ATTACHMENT-4
5 b) The 42/14 Volt automotive

Electrical system
Simulation Results

Figure 25. The Field EMF induced by the Stator Currents (volt)

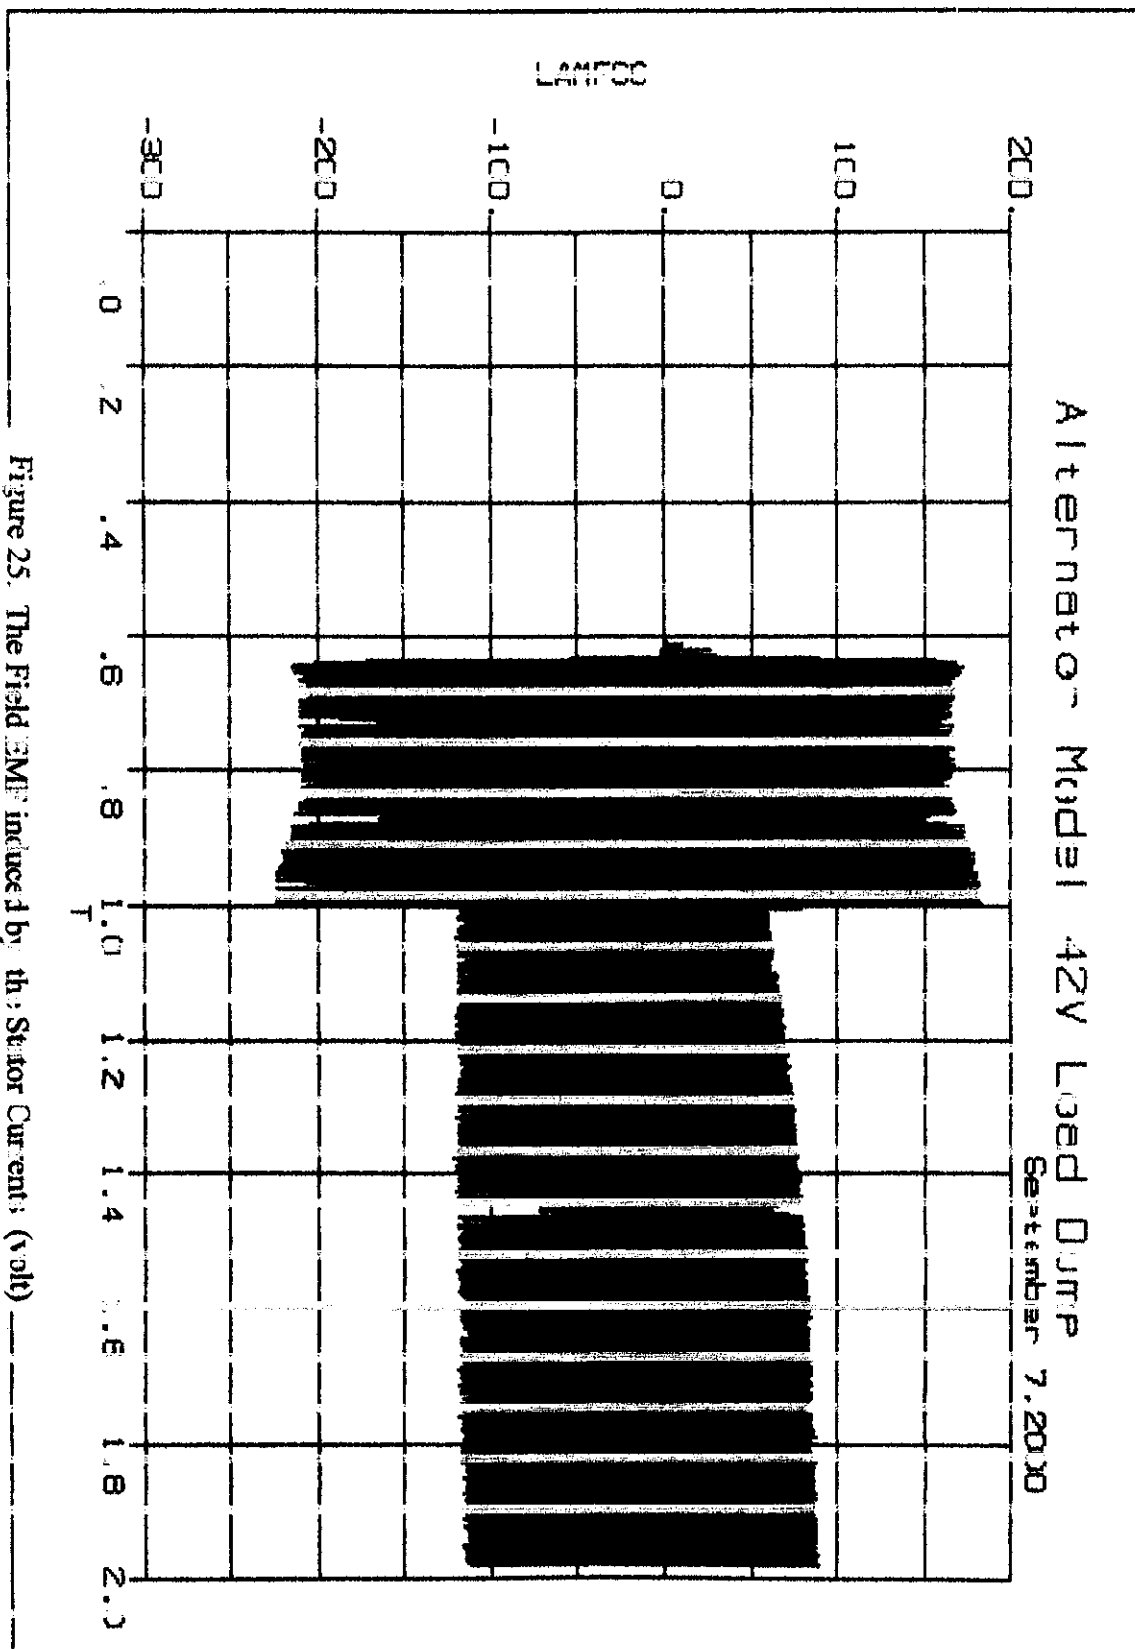
I am glad to see the problem resolved going into 1.05 seconds, although your detailed plot does not show any time after 1.05.

- 1) On the detailed plot, I think the curves indicate you need a much refined time step. Since these are the induced voltages, they should be perfectly smooth sinusoids as on our outputs. You may need to go down a power of 10 to achieve this.
- 2) On the black tornado plot (see attached), there is clearly something wrong between 1.6 and 1.8. Please resolve all qualitative and quantitative items before further fixes. I really have no need to review intermediate results.
